Existing rear - WG.03
Steel window

Proposed rear - WG.03
to match profile details of
existing timber window W1.06

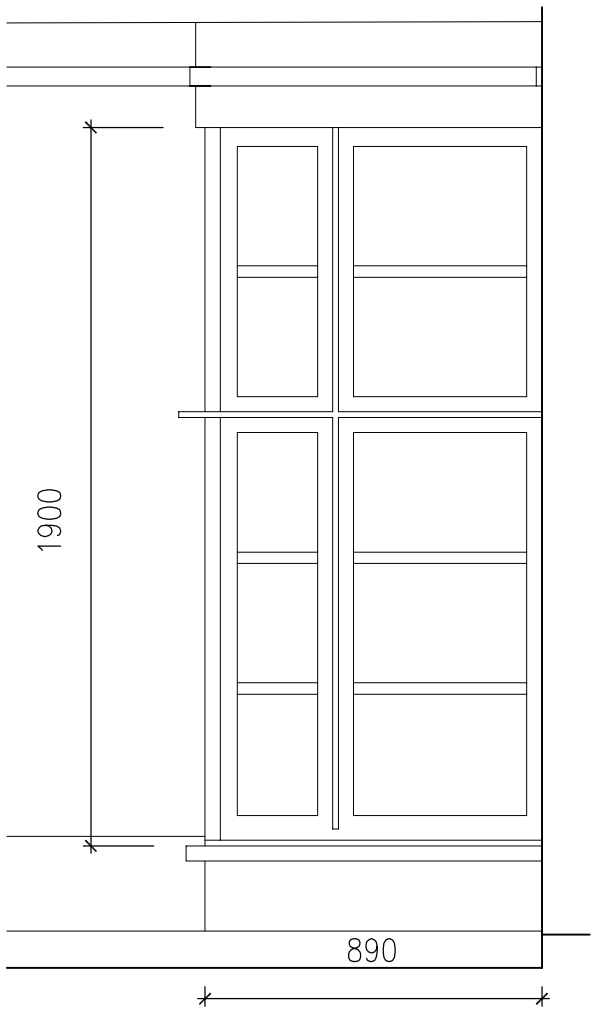
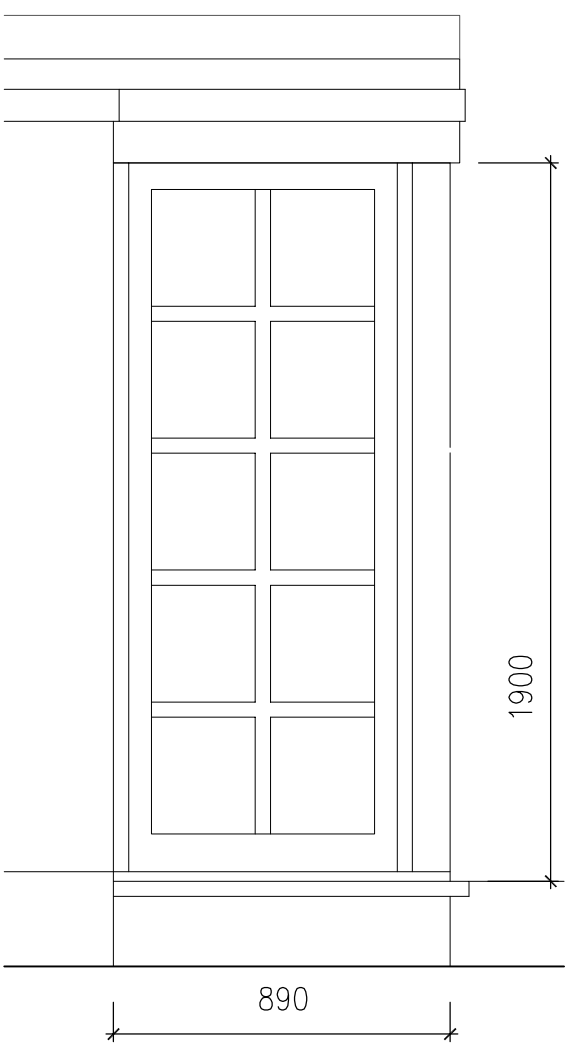
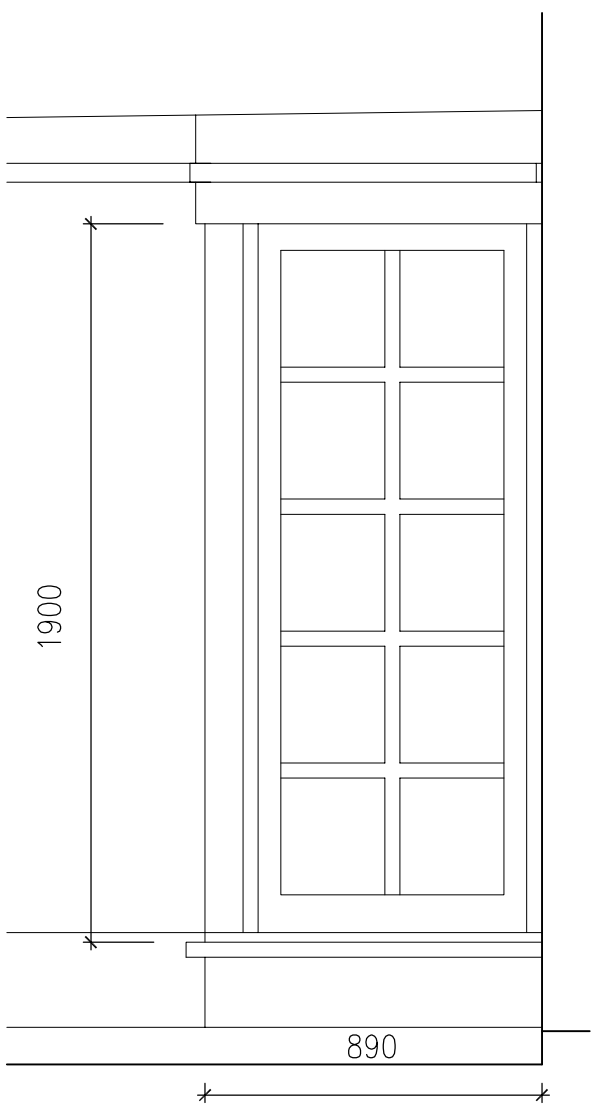
- A. Proposed windows altered to form French windows, one per side. 17/04/17

Proposed side - WG.03
to match profile details of
existing timber window W1.06
